Three BISA Committee members met with AdeLINK project consultants on Tuesday, 1 August 2017, where we were given a [brochure outlining the project](#). This includes an indicative plan showing nothing (**at all**) for cyclists. This is not an oversight but the existing proposal, with works starting immediately.

BISA's feedback

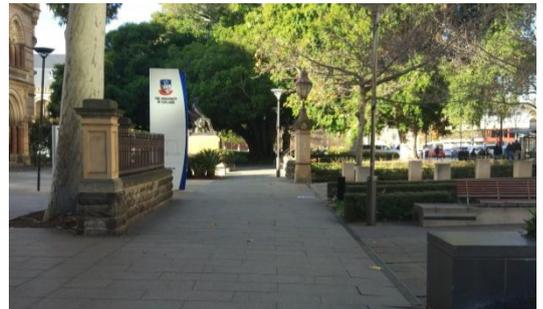
- 1) **Strategic importance of North Terrace:** notably in linking the CBD/ eastern suburbs to the Railway Station; the new High School and Frome Bikeway with the cultural precinct; and for accessing the Unis from the south.
- 2) **High-priority:**
 - For low-speed, local access cycling on North Tce:

The inner pedestrian path on the northern footpath (shown at right) should be changed to a two-way cyclist-only (NOT shared use) path between Kintore Ave and Frome St, and extended to King William St. This path is separated by a low wall to footpath/buildings in many places, and edged by landscaping on the other side, so has good potential as a bike-only path – as long as good design makes it obvious/ intuitive to all. Seating on the larger southern footpath is a fair way from the landscaping. If moved backwards, this would give more walking capacity to offset the inner footpath being changed to bike use.
 - For higher speed, commuter and utility cycling on North Tce:

North Tce should be given a speed limit of 30km/h to allow safe sharing by faster cyclist in the absence of bike lanes. A low speed limit increases capacity for cars and actually reduce congestion (note positive feedback from drivers about the effect of the works zone speed limit on Port Road), is compatible with DPTI's desire/ expectation of road calming, and would help with pedestrian safety crossing to/from central tram stops. A road works speed limit of 25km/h will be in place while the works are underway, so a 30km/h wouldn't be a major impost once North Tce is fully opened in its new form.
 - For low-speed, local access cycling on King William St:

The eastern footpath on King William St to be changed to allow for cyclist travel uphill.
- 3) **Other** (re: more detailed aspects of the plan):
 - Provide on-road bike lanes from Frome Rd to East Tce – there's enough room for this currently and with some effort, bike lanes could be designed in. This would connect to path networks through the Park Lands.

- Provide hook turn marking for right turn, North Tce to Kintore Ave. This movement is to be banned for cars but should be retained for cyclists.
 - If possible, road space in North Tce should be allocated so that it has more width at the kerbside than median side (assuming this won't reach the 3.2m at which cars will start to be tempted to overtake cyclists).

- Try to address danger to cyclists from crossing tram tracks. We suggest a bike box on the eastern side of King William St/ North Tce, so cyclists can turn right from the through lane and cross the tracks at a better angle. (Currently, there are two right turn lanes at this location but one of these will be removed.)

- During works, replace existing bike racks on North Tce with temporary bike racks as these are well used. (All street furniture will be pulled out during construction works.)
